METROPOLITAN GOVERNMENT OF NASHVILLE AND DAVIDSON COUNTY

STAFF RECOMMENDATION 2216 29th Avenue South August 21, 2013

Application: New construction—addition and outbuilding; Setback reduction
District: Hillsboro-West End Neighborhood Conservation Zoning Overlay
Council District: 18
Map and Parcel Number: 10414009500
Applicant: David Baird
Project Lead: Melissa Baldock, melissa.baldock@nashville.gov

<p>Description of Project: Application is to construct a rear addition that is taller than the historic house and to construct a new outbuilding. The addition requires a setback reduction.</p>	<p>Attachments A: Photographs B: Site Plan C: Elevations</p>
<p>Recommendation Summary: Staff recommends approval of the project with the condition that staff review and approve the asphalt shingle color and all windows and doors prior to purchase and installation.</p>	
<p>With these conditions, staff finds that the project meets Section II.B. of the <i>Hillsboro-West End Neighborhood Conservation Zoning Overlay: Handbook and Design Guidelines</i>.</p>

SITE PLAN

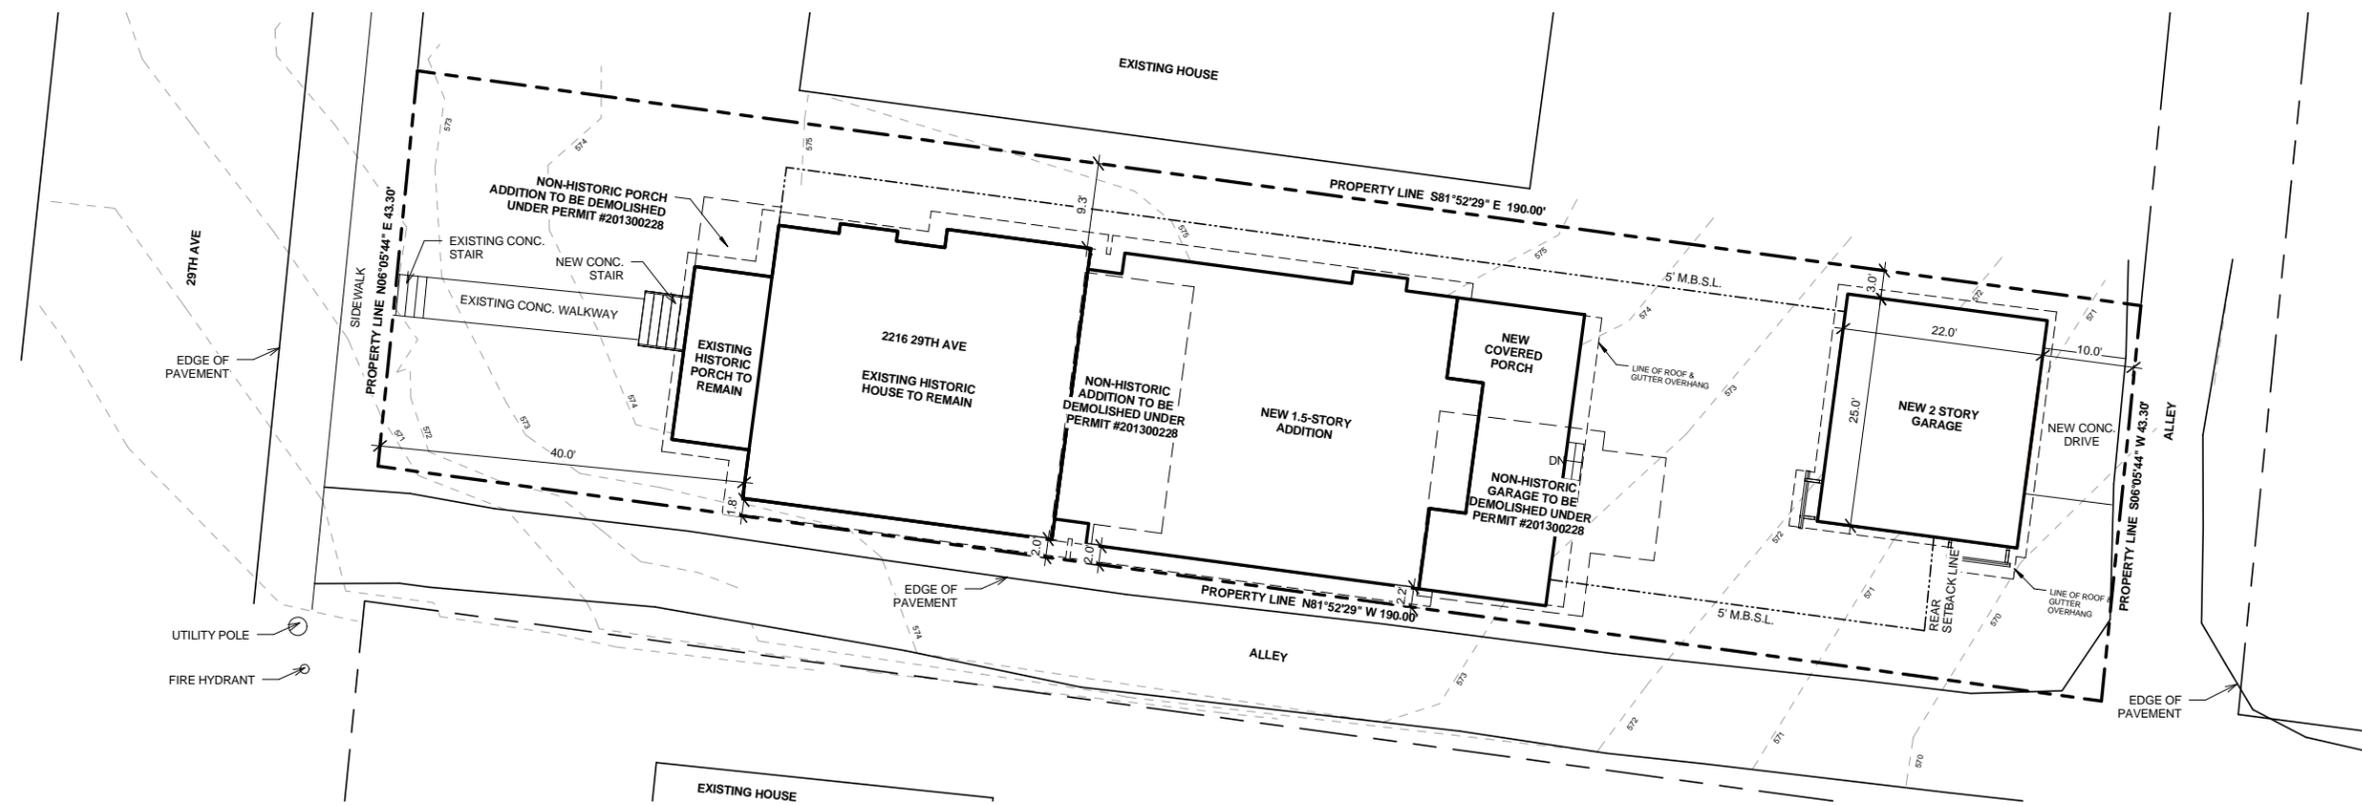
Location and Setback. The new addition will be no wider than the existing house, and will be located behind the historic house. The existing house does not meet the base zoning setback on the right side property line, which abuts an alley. The house is slightly skewed so that the front of the house is just one foot, eight inches (1'8") from the property line and the back of the existing house is two feet (2') from the side property line. After an initial inset, the new addition will line up to match the side walls of the historic house, and will also not meet the base zoning setbacks. The addition will be between two feet (2') and two feet, two inches (2'2") from the side property line. Staff finds that the proposed setback reduction is appropriate because the addition will not be any closer to the side property line than the existing house. In addition, the side property line abuts an alley, and therefore the reduction will have less impact on neighboring

property owners. Staff therefore finds that the structure meets Sections II.B.1.c. and II.B.2. of the *Hillsboro-West End Neighborhood Conservation Zoning Overlay: Handbook and Design Guidelines*.

BUILDING ELEVATIONS

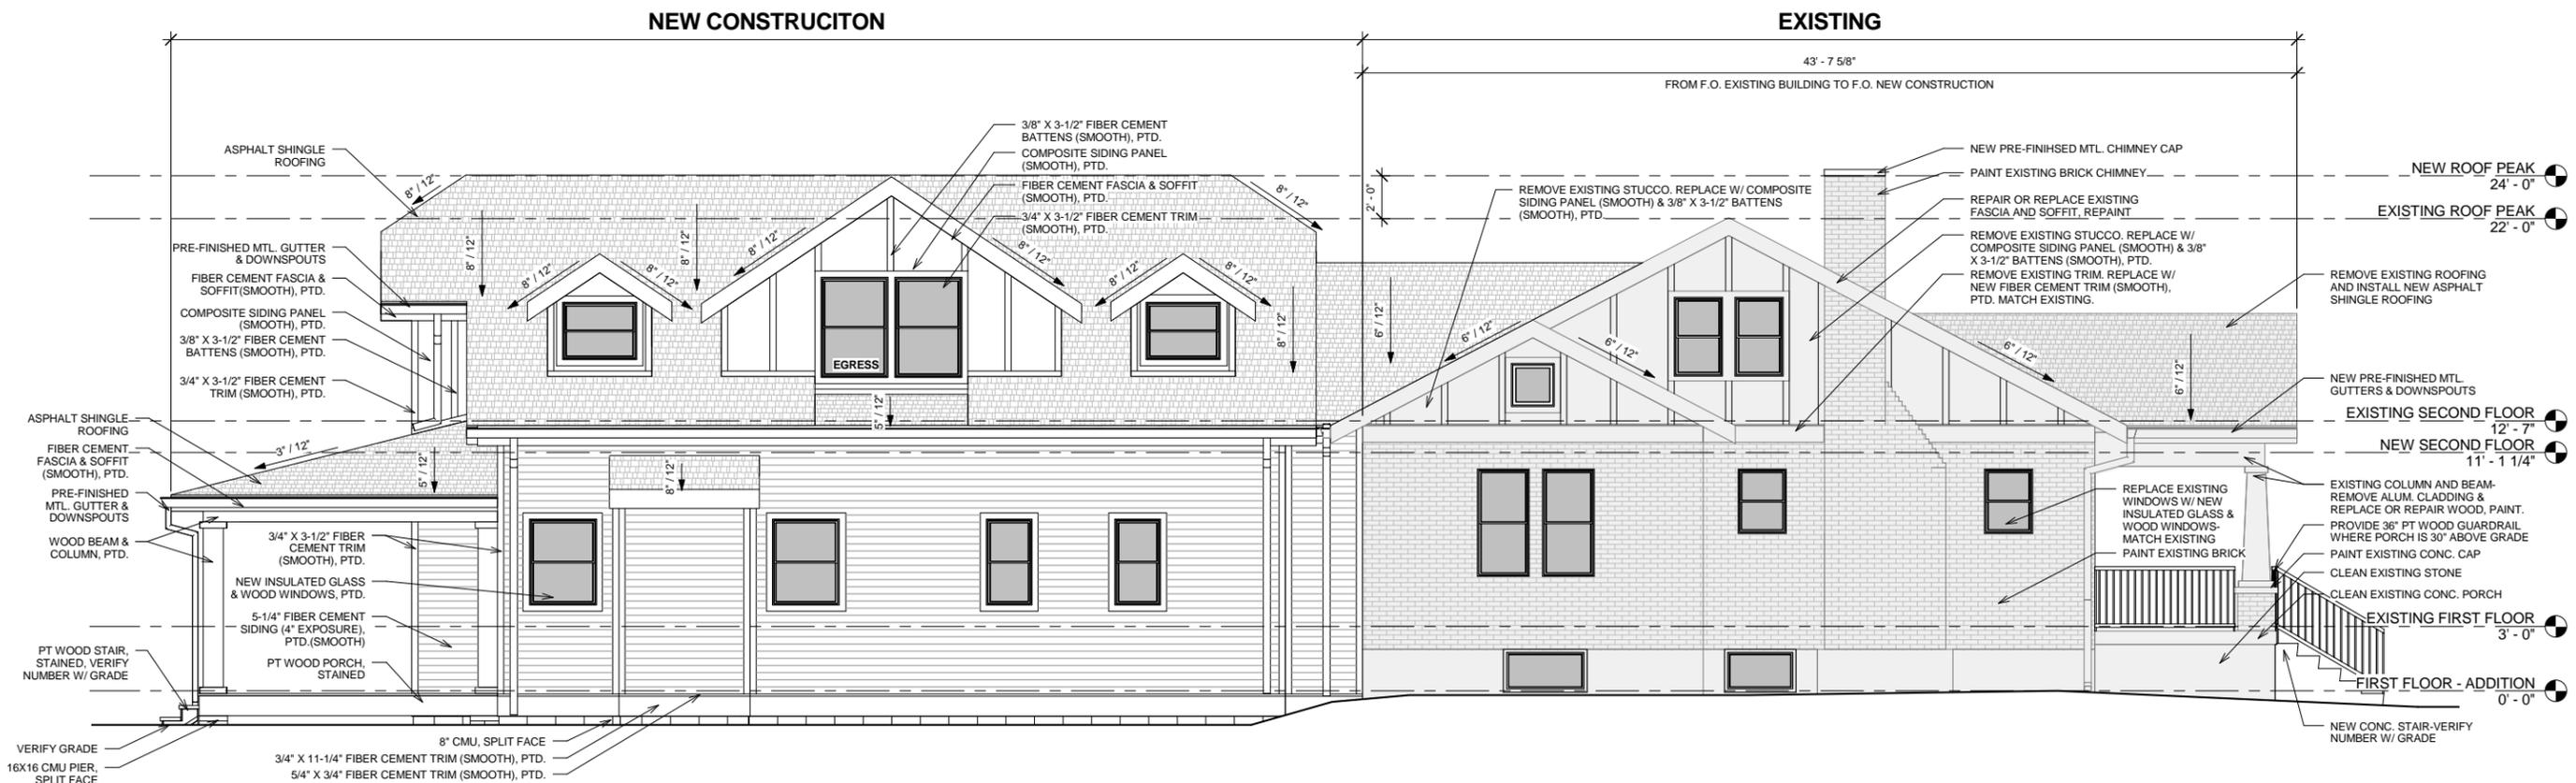
Height and Scale. The existing historic house has a maximum width of thirty-two feet (32') and is forty three feet (43') deep. It is approximately twenty-three feet (23') tall. On both sides, the proposed addition steps in from the sidewalls of the historic house two feet, four inches (2'4") for a depth of three feet, eight inches (3'8"). After the inset, the addition steps back out to match the line of the house's sidewalls. Staff notes that on the left side is a ventless chimney bump out that extends one foot, four inches (1'4") beyond the house's historic sidewall. In the past, the Commission has not considered chimney bump outs to be part of the main form of the house and has allowed them to extend beyond the line of the historic house. The addition will have a maximum depth of fifty-four feet, four inches (54'4"), which includes a ten foot (10') deep porch at the rear.

The addition will be two feet (2') taller than the historic house. The design guidelines allow additions to be up to four feet (4') taller than the historic house when the taller portion of the addition is at least forty-feet (40') behind the front of the house, the addition is inset appropriately, and the roof of the addition is a clipped, hipped, or side gable form. In this case, the taller portion of the addition starts approximately forty-four feet (44') behind the front of the house, steps in appropriately, and has a clipped gable roof. Allowing for additional height on the second level, prevents the addition from using up all the rear yard area. Staff therefore finds that the taller addition meets the design guidelines.

Roof Form: The historic structure has a side-gabled roof with a gabled front porch with a slope of 6/12. The proposed addition ties into the back slope of the gable below the ridge with a gabled roof form with a 6/12 slope. The proposed addition has a clipped gable roof form with a slope of 8/12. The proposed dormers, which are setback at least two feet (2') from the side walls of the house, have gabled roofs with an 8/12 pitch. The rear porch has a shed roof with a slope of 3/12, and the ventless fireplace bump outs will have a shed roof with a slope of 5/12. Although the addition's main form has a steeper roof pitch than that of the historic house, staff finds that the 8/12 pitch does not contrast greatly with the historic house's 6/12 pitch and helps to reduce the effect of the massing of the addition. Staff finds that the proposed roof form of the addition meets Sections II.B.1.e. and II.B.2. of the *Hillsboro-West End Neighborhood Conservation Zoning Overlay: Handbook and Design Guidelines*.

Date: 8/12/2013
GARAGE FLOOR PLANS

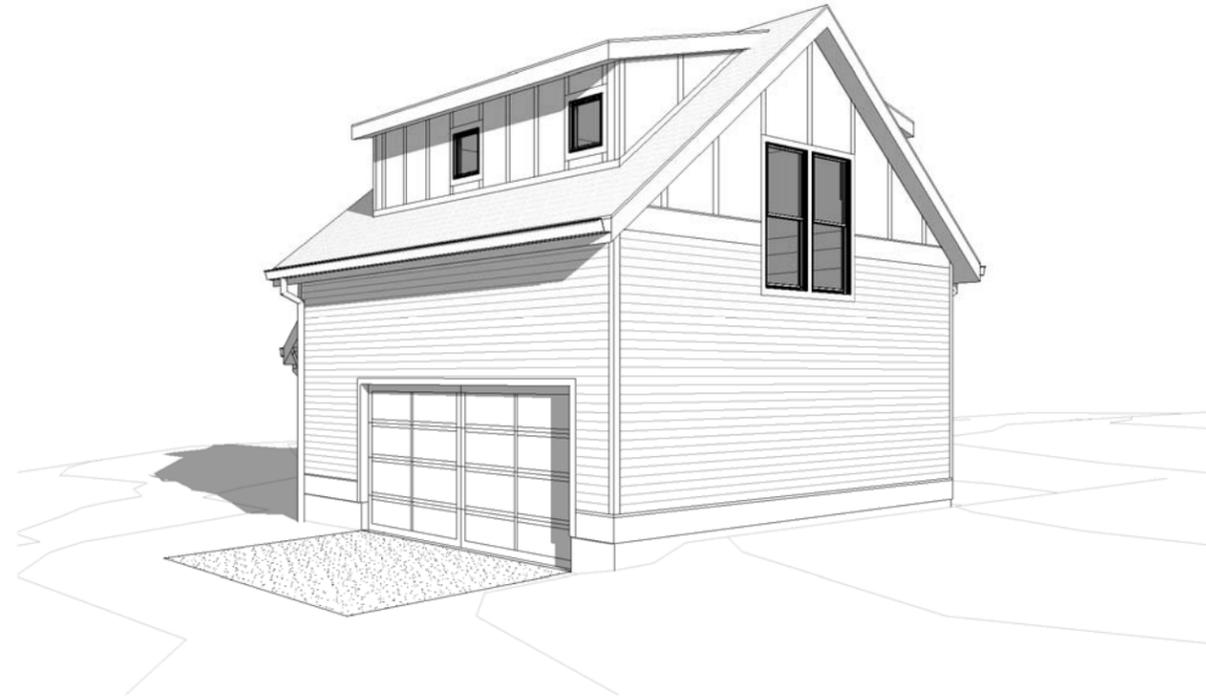
Outbuildings: The proposed new one-and-a-half story garage will be located at the rear of the property and will be accessed via the rear alley. It will meet all base zoning requirement for setbacks. It will be twenty-two feet by twenty-five feet (22'X25'). It will have an eave height of approximately twelve feet (12') and a ridge height of approximately twenty-three feet (23'). The proposed garage's height will nearly match that of the historic house. However, because of the slope of the site, the ridge of the garage will be three feet (3') lower than that of the house when grade is taken into consideration. The slope and the garage's modest footprint help make the outbuilding subordinate to the historic structure, and staff finds that the outbuilding's height and scale meet the design guidelines.

The roof will be gabled with a 10/12 slope. The structure will have shed dormers with a 3/12 slope. The materials will be similar to those of the addition. The structure will be clad in cement fiberboard lap siding. The roof will be asphalt single, and staff asks to

review the color of the shingle. The proportion and rhythm of openings are appropriate for an outbuilding. Staff finds that the proposed garage meets Section II.B.1.h. of the *Hillsboro-West End Neighborhood Conservation Zoning Overlay: Handbook and Design Guidelines*.
